## Broadmeadow Estuary Greenway ABP Submission July 2019 - ABP Reference PL06F.304624

### 1.0 Introduction

Extract from Drawing 12-160-256

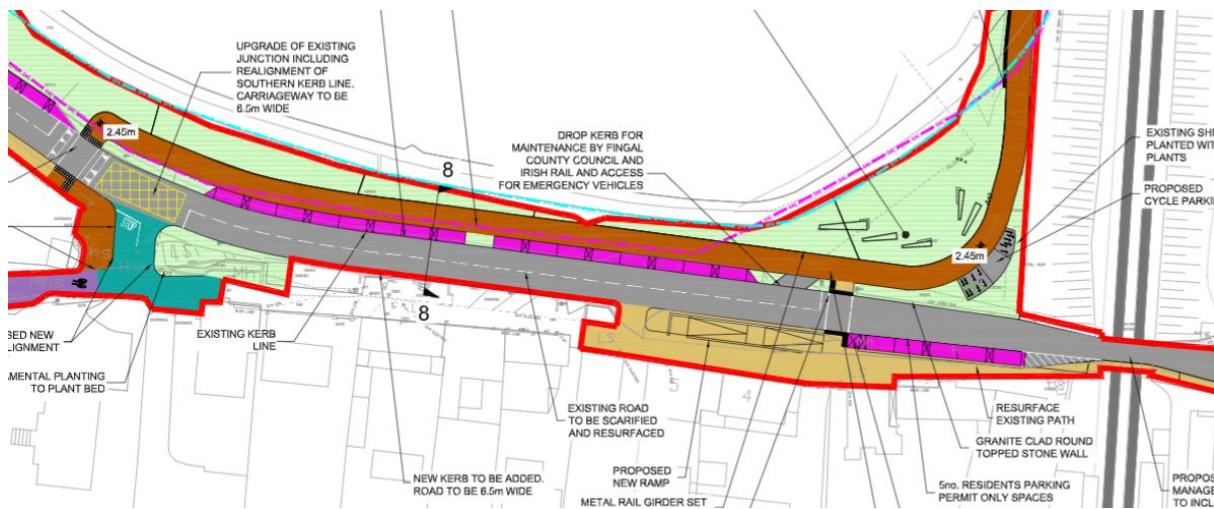
The most disappointing aspect of the Bissetts Strand proposed design is the proposed increase in car parking in the area, while limiting the width of the proposed greenway track, and without any buffer proposed between the proposed parked cars and the greenway. This can be seen directly in the images below from

As the 'before' and 'after' images clearly demonstrate, priority in the design of this proposed greenway has clearly been given to car usage, and not to greenway usage. This is unacceptable.

We also note the omission in this section of access to the proposed greenway from Malahide Village via the railway bridge, despite the proposed provision of cycle priority through the Railway Arch, as shown on the drawing. No provision has been made to access the Greenway west of the Railway Bridge.
